**ADDENDUM
NO. 2**

November 3, 2022

**LIBERTY ELEMENTARY SCHOOL RENOVATIONS
Chesterton, IN 46304**

This Addendum consists of Pages ADD 2-1 through ADD 2-3 and attached Addendum No. 2 from Gibraltar Design dated November 2, 2022 and consisting of 7 pages, Specification Section 08 33 00 - Rolling Doors and Grilles, and 41 Drawings.

GIBRALTAR DESIGN SHEET
A-420

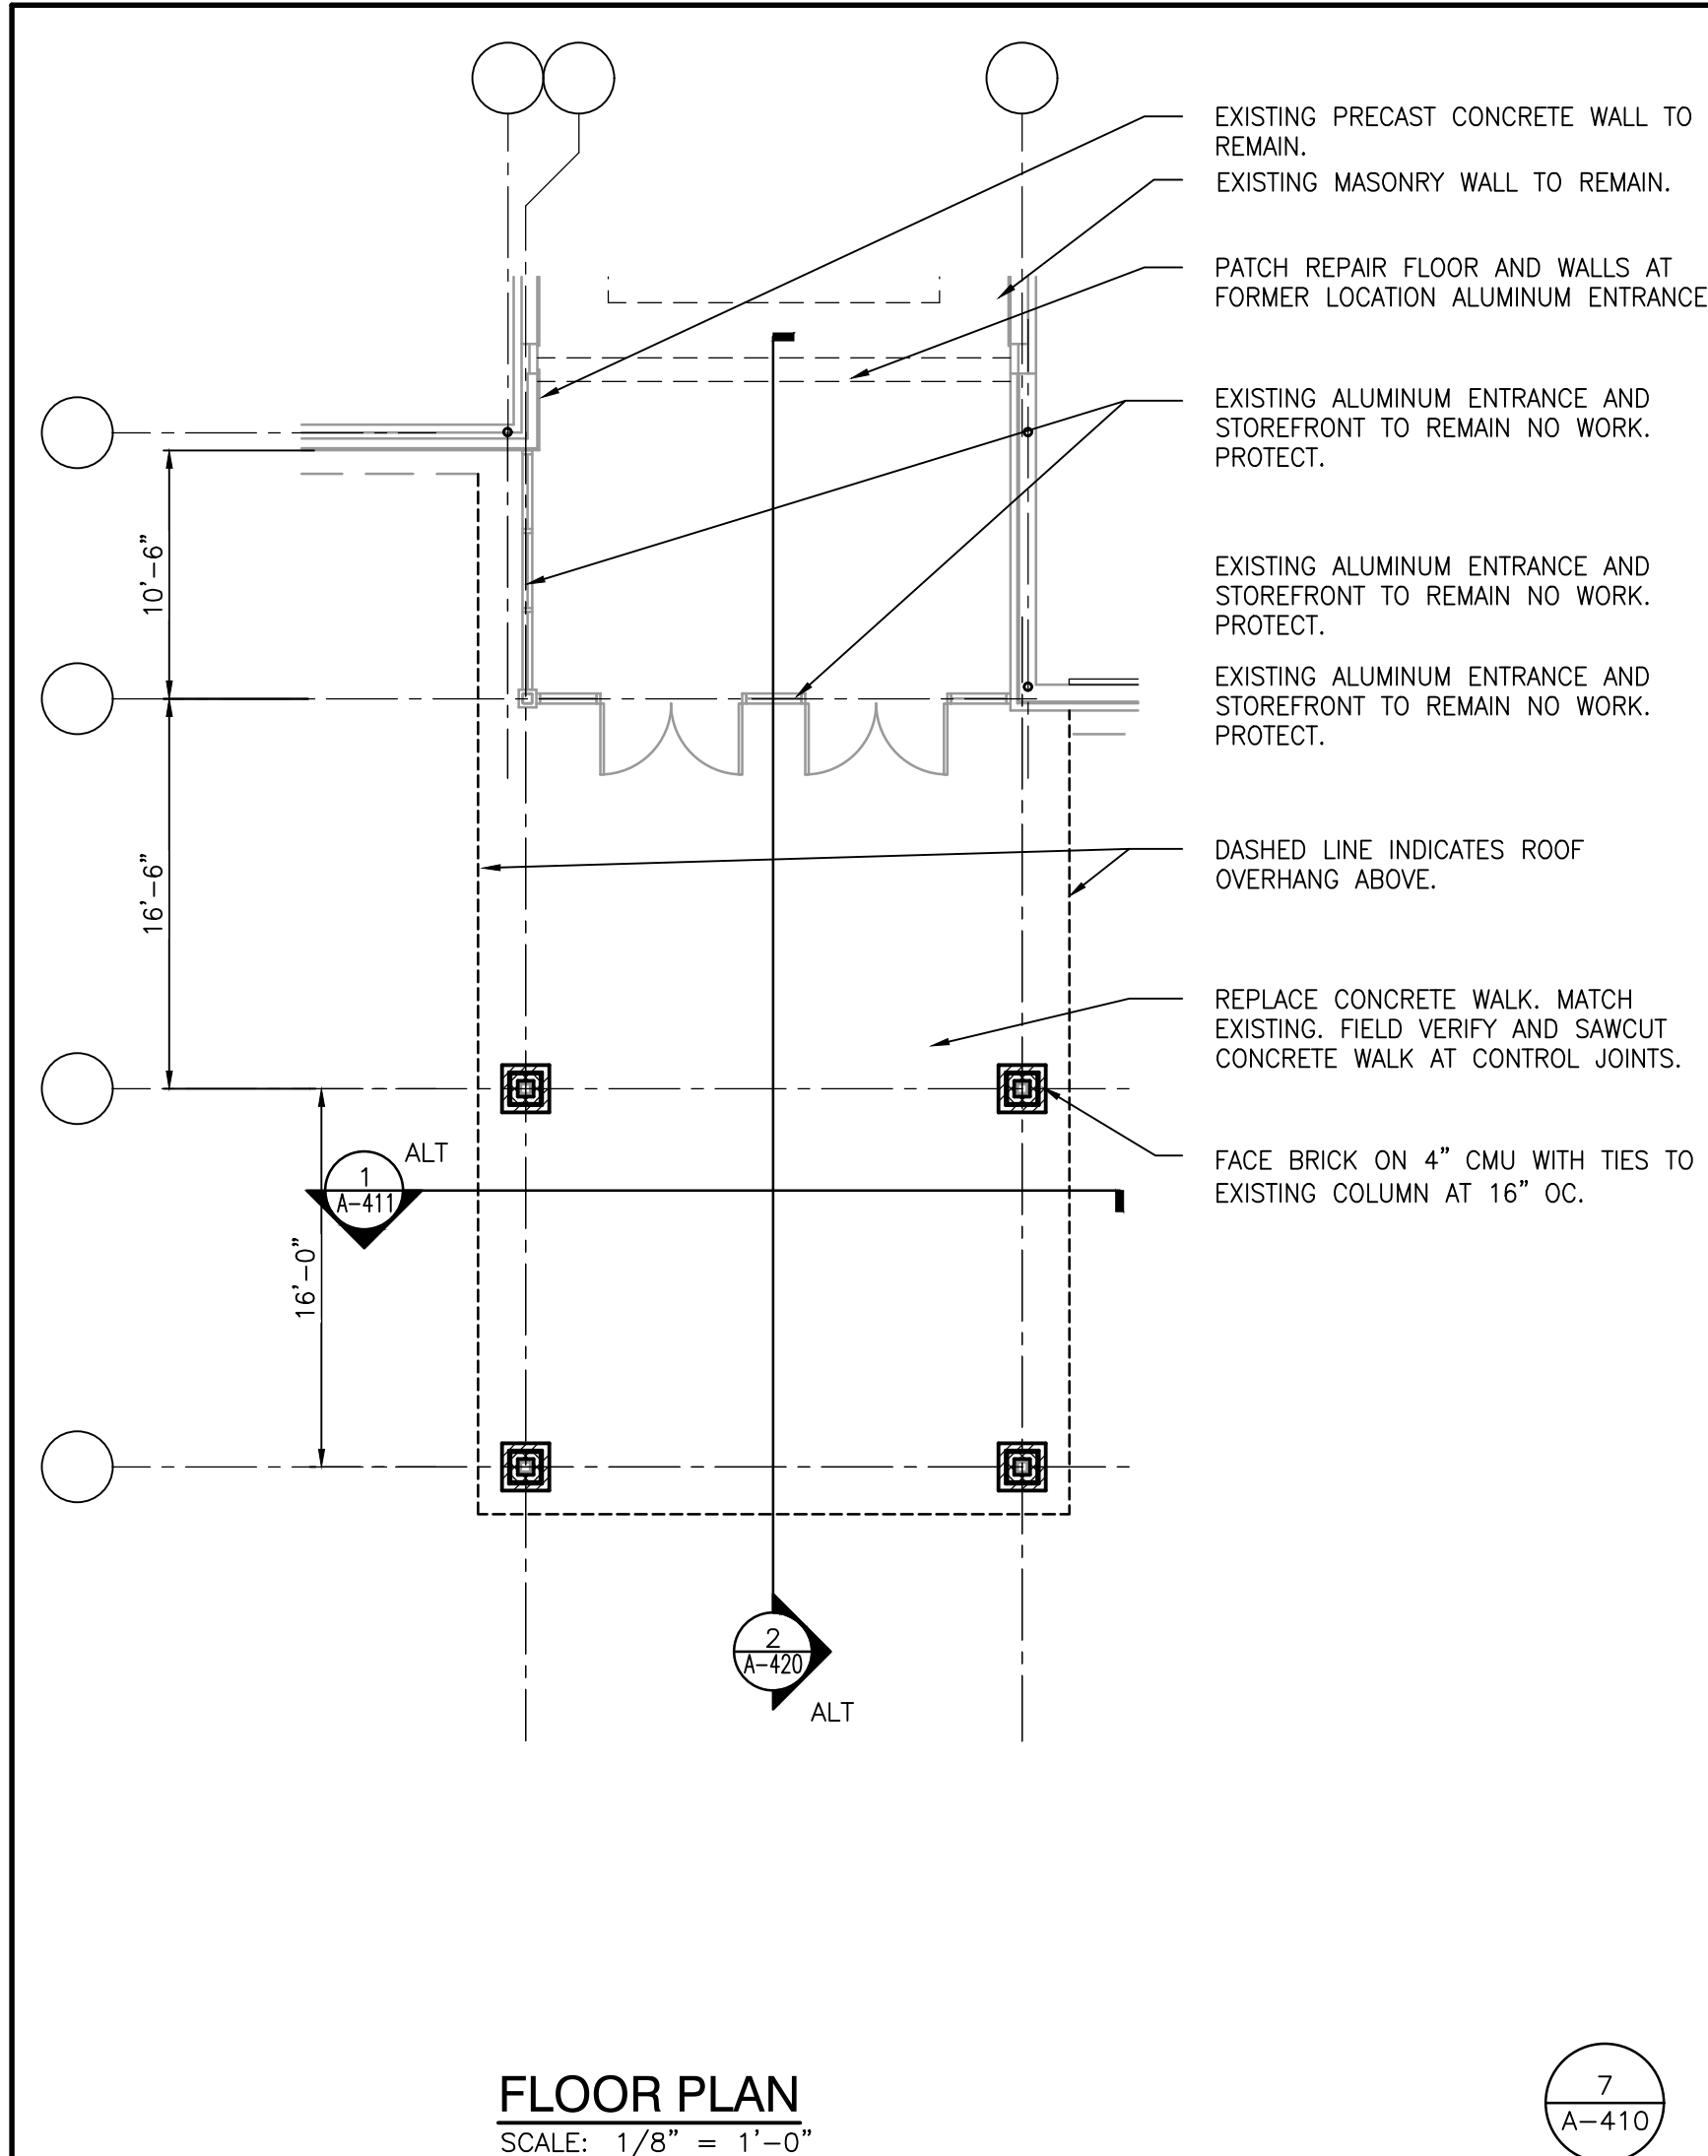
16. Sheet A-420

- A. Refer to revised full size drawings, included in this Addendum, for the following revisions:
1. Add dimensions for height of brick columns and offsets from existing column centerline.
 2. Clarify foundations shown in Wall Section 1/A-420.

AD-2 ENTIRE SHEET SUBMITTED IN ADDENDUM 2

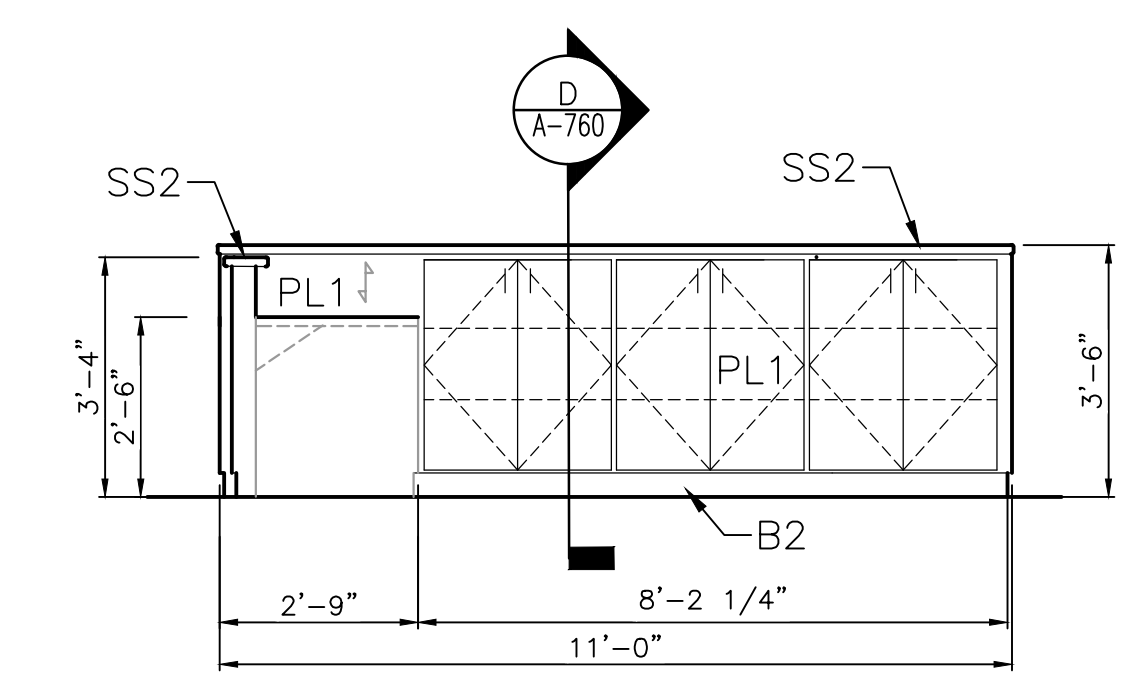
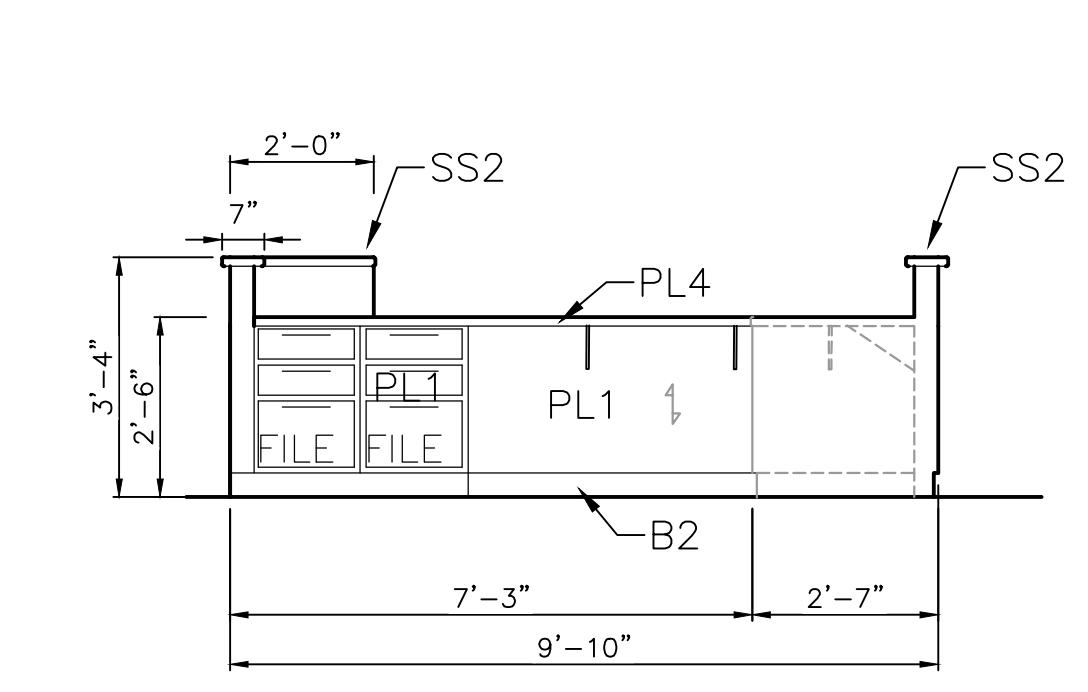
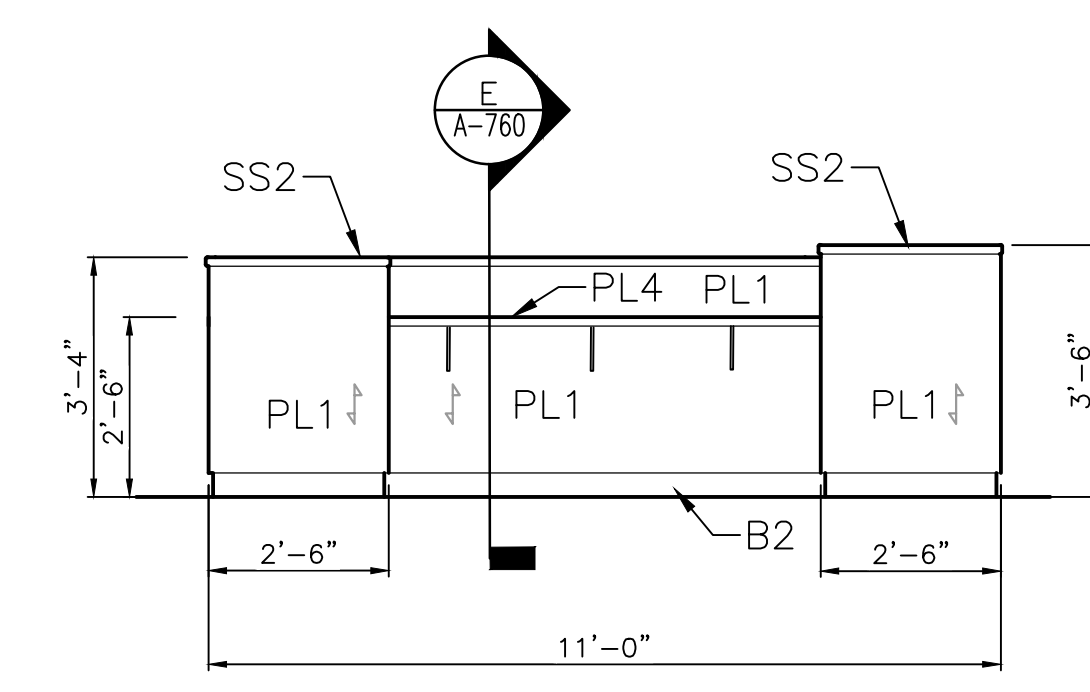
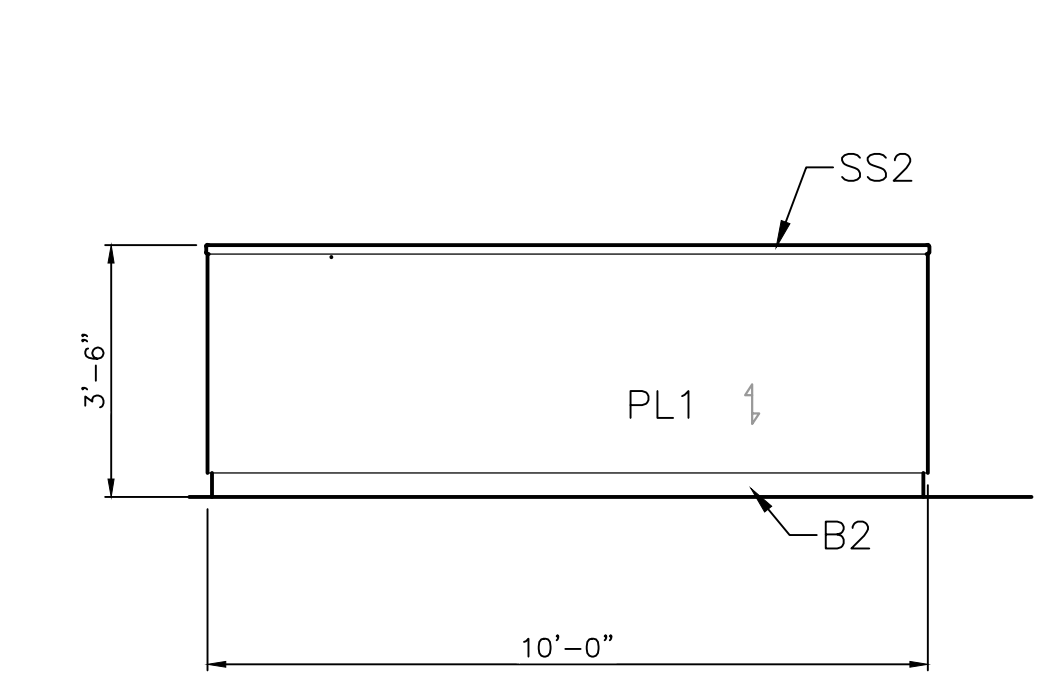
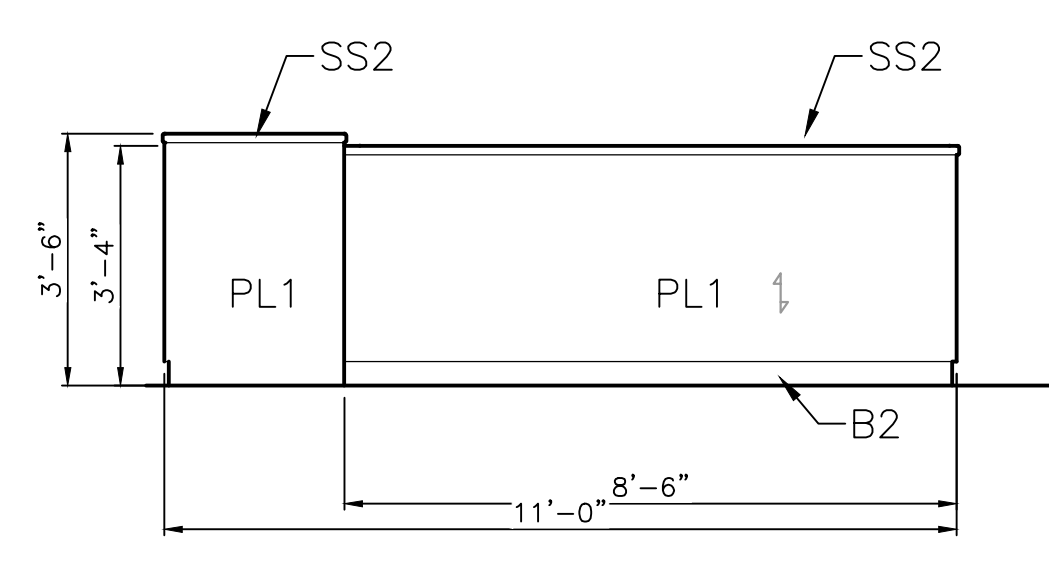
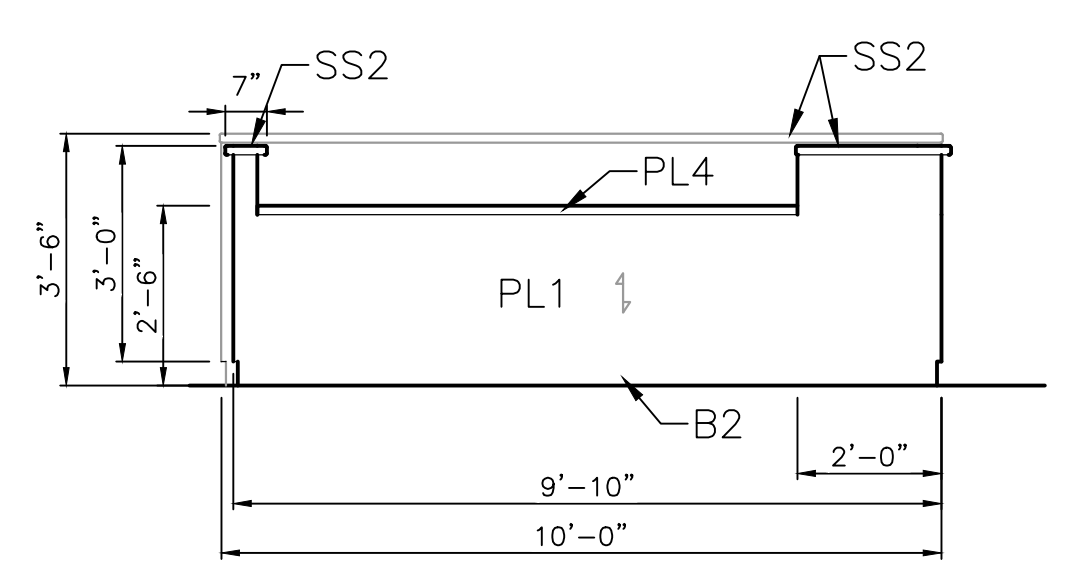
19. Sheet A-760

- A. Refer to revised full size drawing, included in this Addendum, for the following revisions:
1. Addition of Circulation Desk plan, elevations and details.
